RE: **Winrock Road Town Center**
2100 Louisiana Blvd NE
Drainage Master Plan- Drainage Implementation Plan
Engineer's Stamp Date: 5/16/19
Hydrology File: J19D058

Based on submittal received on 5/17/19, the Drainage Implementation Plan cannot be approved for Site Plan for Building Permit until the following are corrected:

RE: Winrock Town Center Drainage Implementation Plan
Hydrology File: J19D058

WINROCK TOWN CENTER DRAINAGE IMPLEMENTATION PLAN

WINROCK TOWN CENTER PHASE B INFRASTRUCTURE IMPROVEMENTS			
TITLE: STORM DRAIN AP-D 100			
Design Review Committee	City Engineer	Ms./Day/Yr.	Ms./Day/Yr.
City Project No.	Zone Map No.	Sheet	Of
4553.90	J-19-Z		EXHIBIT 5

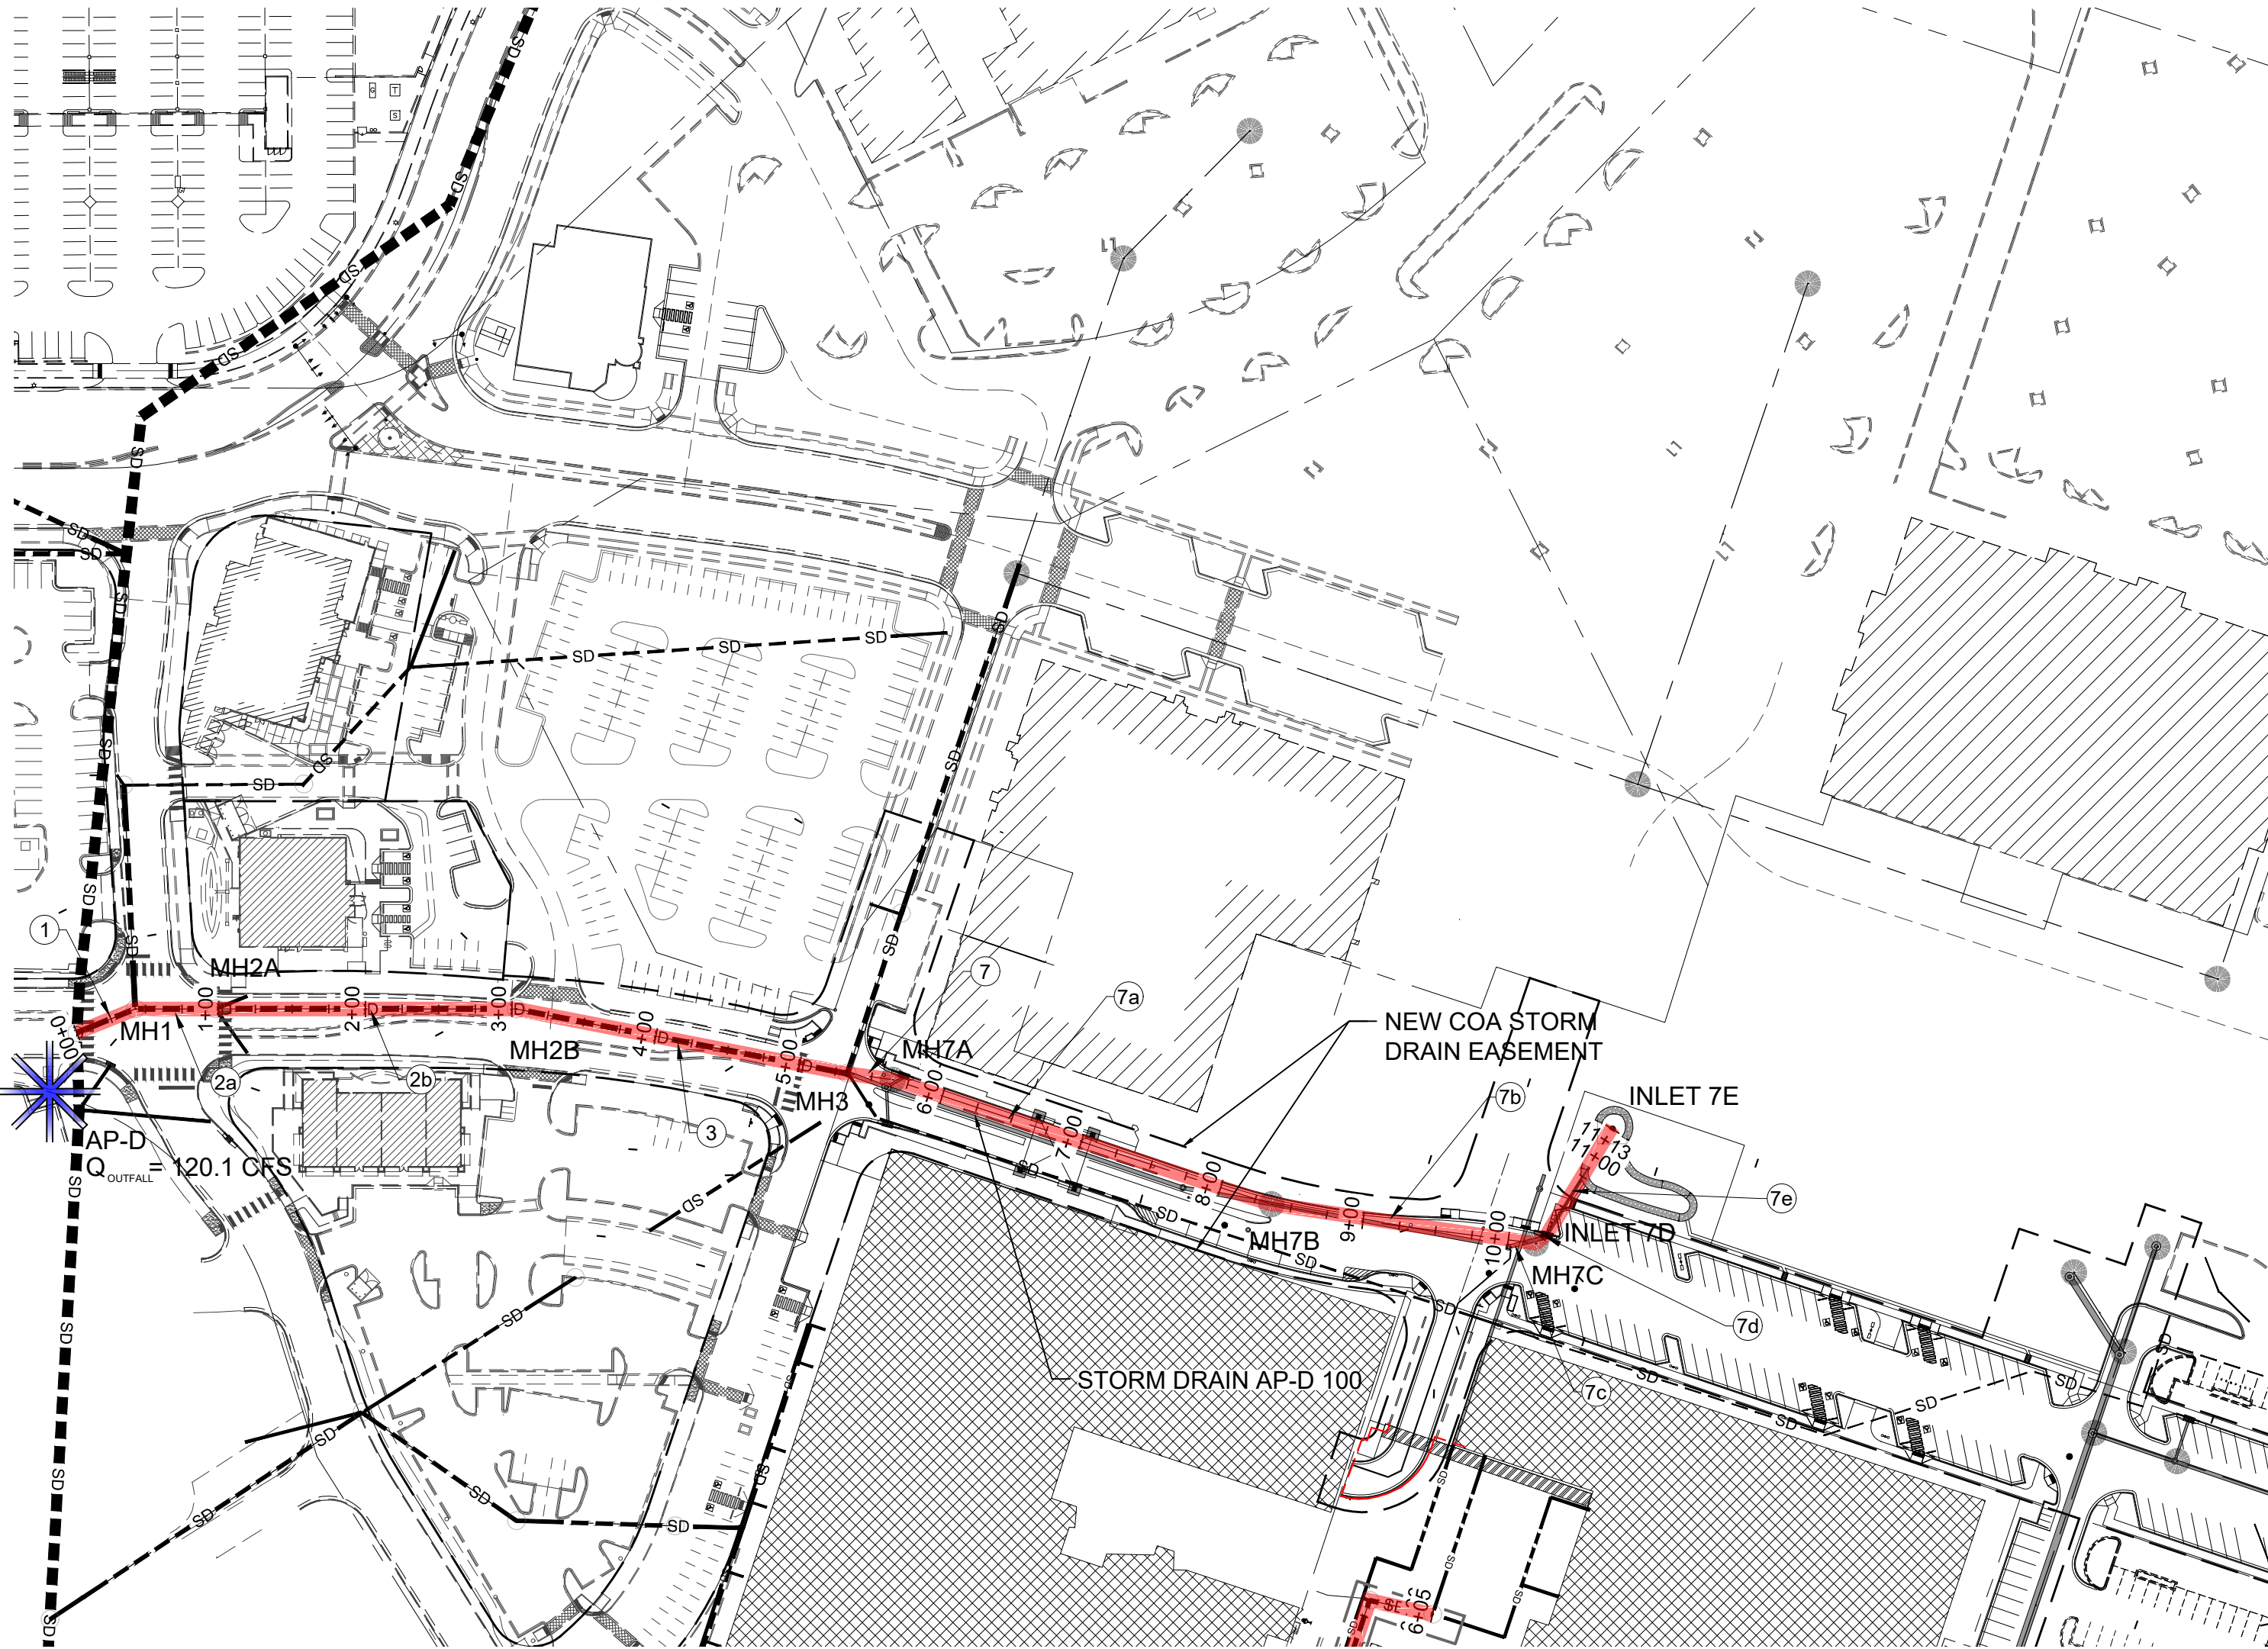
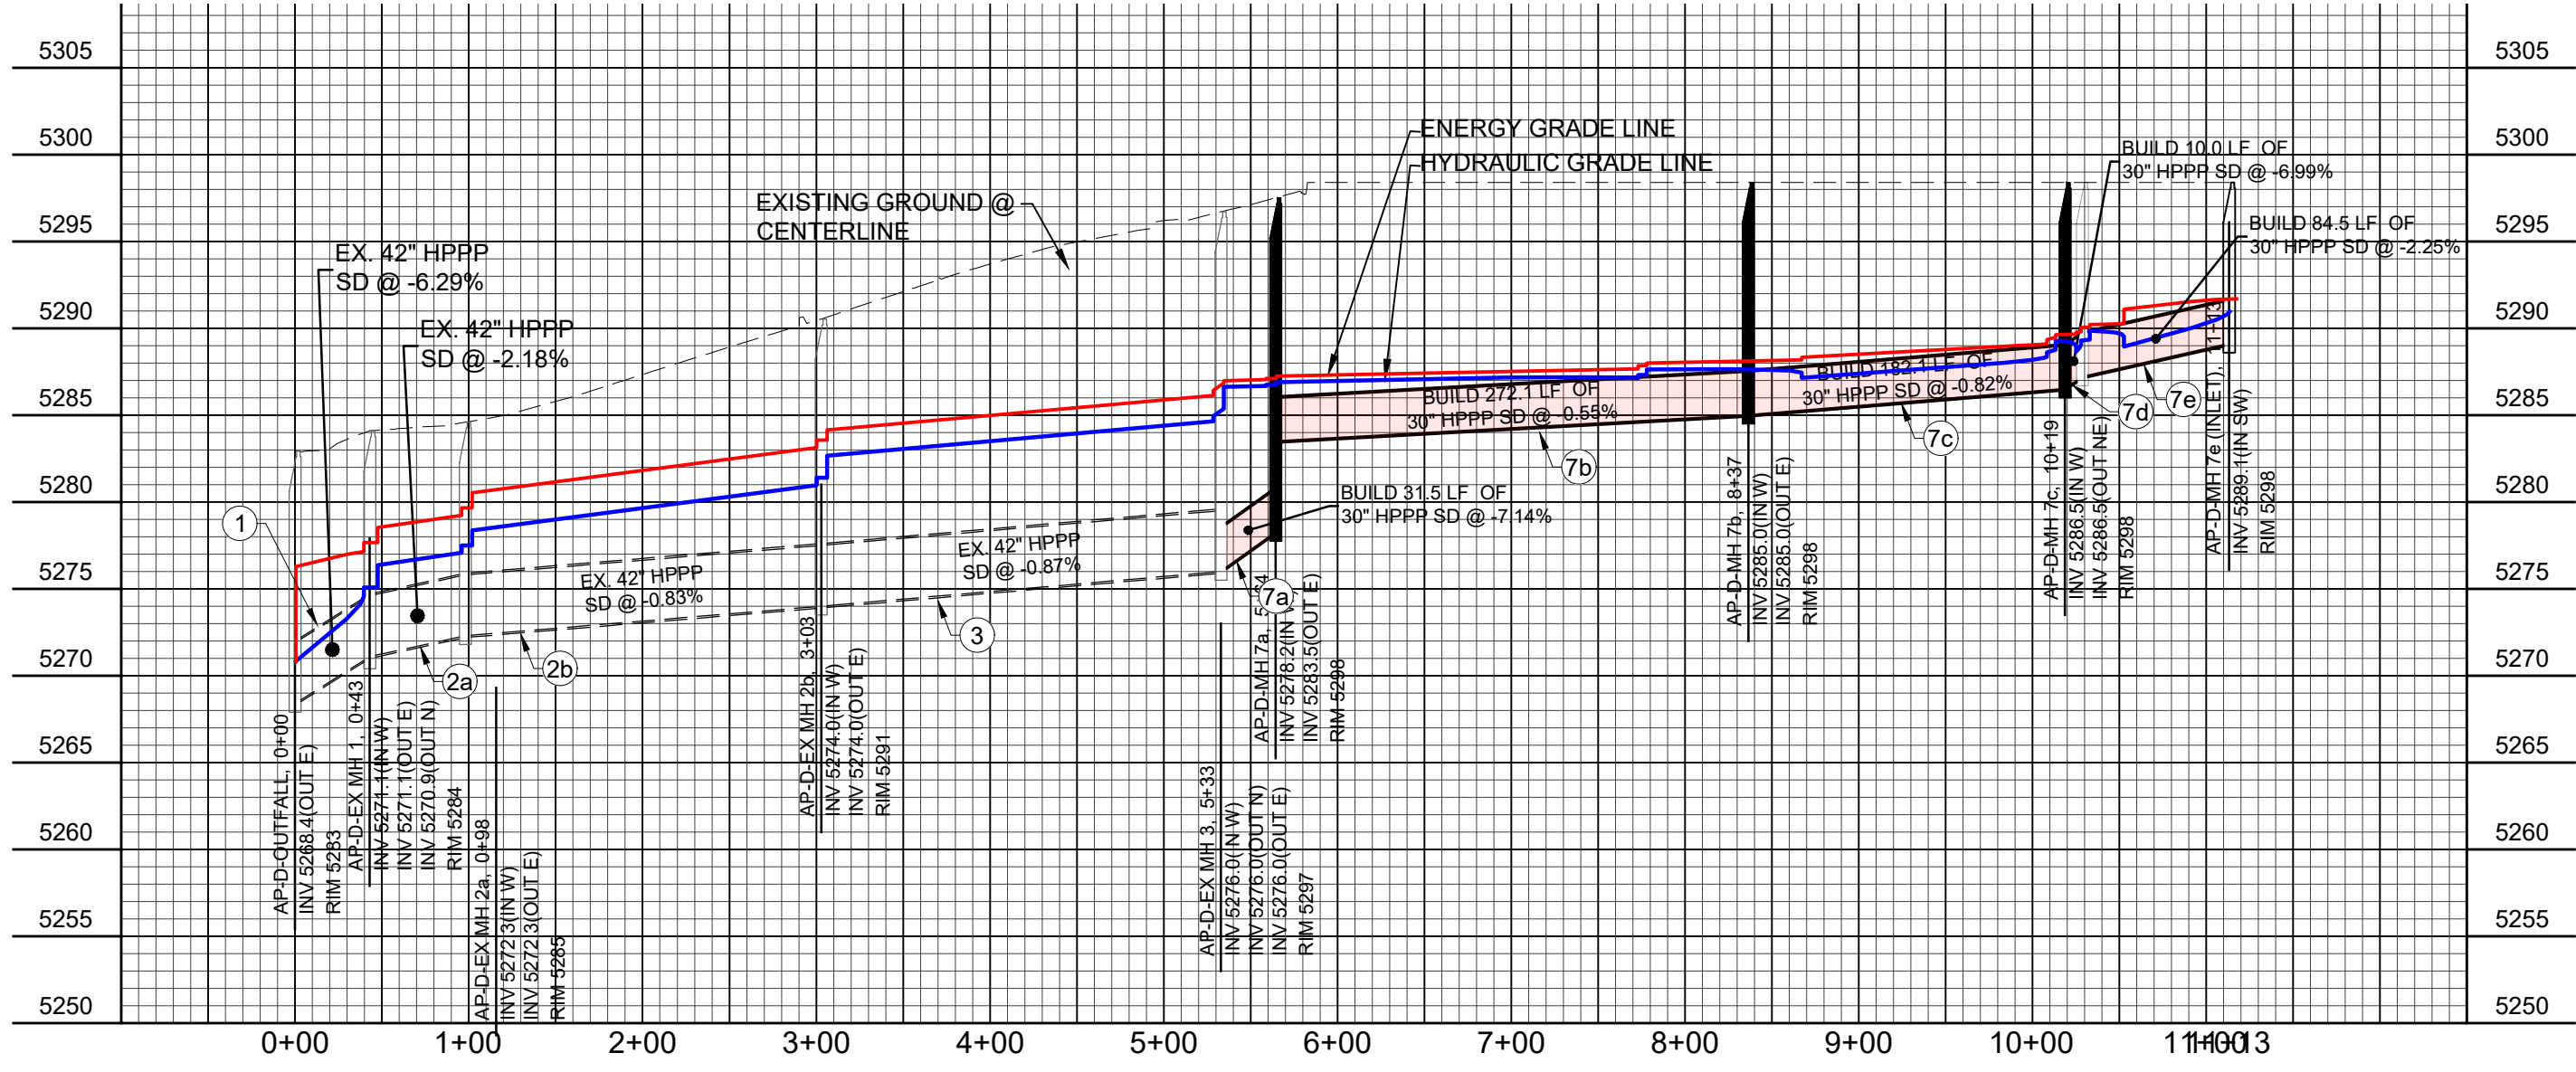
- ii. pipe 6 Q is shown as 24cfs on the table, but is shown as 51cfs on the exhibit 1 table.
 - e. On Exhibit 5, pipe 7a-7e are called out as 30" in profile, but are 24" in the table and 42-30" on the exhibit 1 table
